Access Compliance Report Public Rights-of-Way (Curb Ramps)

Main Street: NEWLAND_ST Cross Street: BOLSA_AVE Location: SW

ADA ID: RPRK210929130641 Ramp Type: Type 1 - Perpendicular Diagonal Initial Pass/Fail: Pass Overall Compliance: No Severity Score: 8

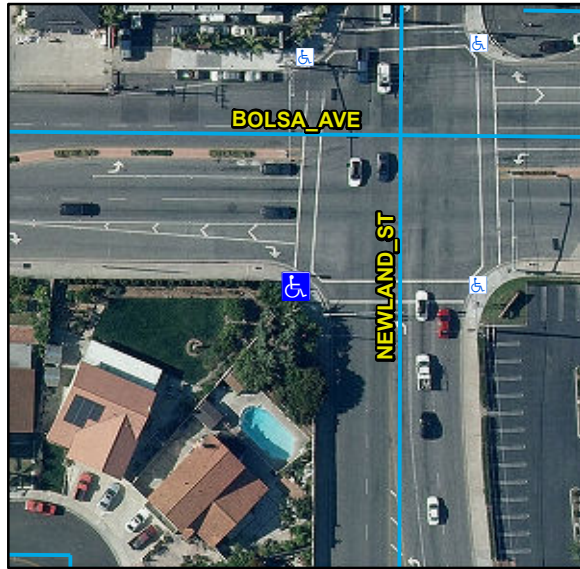
Remove & Replace Curb Ramp With Two New Directional Ramps or Equivalent. Remove & Replace Gutter.

R304.2.2, R304.2.1, R304.5.3, R302.7, STD 1115

N/A	Ramp Inside Crosswalk 1	N/A	Yes	Ramp Inside Crosswalk 2	N/A
	Crossing 1 Slope (%)	1.4		Crossing 2 Slope (%)	0
	Crossing 1 Cross Slope (%)	0.6		Crossing 2 Cross Slope (%)	0.2
No	Gutter Ponding	Yes	No	Curb Slope	5.6
Yes	Gutter Lip Height (in)	0		Road Run Slope (%)	0.5
Yes	Gutter Run Slope (%)	0.8		Road Cross Slope (%)	3.5
No	Gutter Cross Slope (%)	2.6			
Yes	Overall Surface Condition: Acceptable		Yes	Perp Joint Present	Yes
	Cross Gutter Present?	No		Spandrel Present?	No
	Replace Cross Gutter?	N/A		Replace Spandrel?	N/A
